STUDEBAKER-PACKARD CORPORATION

Service Bulletin

MARCH 1961 NO. 360

FIG. 2

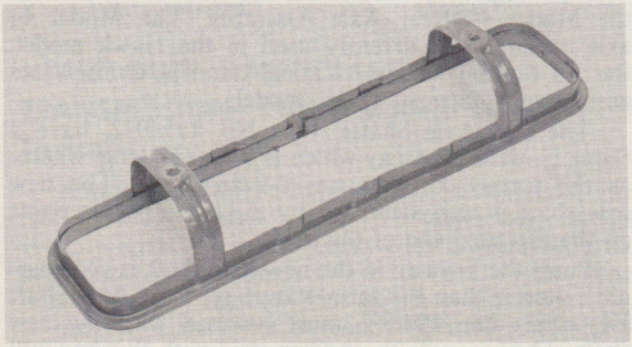
Oil loss during the adjustment process can be prevented by the use of a modified rocker arm cover and cover gasket. The modified cover acts as a baffle yet permits ready access to the rocker arm adjusting screws.

The modified cover can be made in your own service department by cutting an existing rocker arm cover as shown in Fig. 2.

FIG. 3

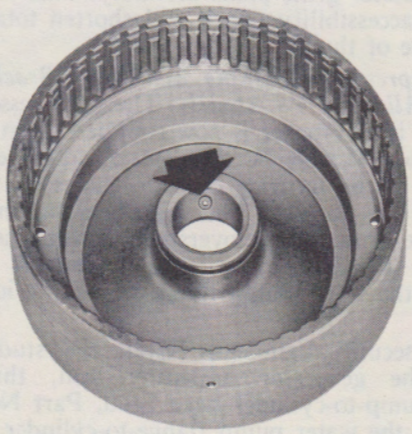
If you encounter a complaint of a slow engagement and/or a bump when shifting into 'D' or 'L' position in transmissions before the above transmission serial numbers, you should install the following parts and modify the front clutch cylinder as follows:

1. Replace the 3 front clutch discs with 3 new discs, Part No. 1554230, (4 for Taxi and Heavy-Duty transmissions).
2. Replace the front clutch pressure plate with a new Pressure Plate, Part No. 1554179. The new pressure plate should be installed in the standard transmission *only* and *must not* be used in the Taxi Heavy-Duty type transmission.
3. Drill out the front clutch inlet hole located in the front clutch cylinder to a 5/32" diameter hole. The present orificed end of the inlet hole is .075" to .081". (See Fig. 3)
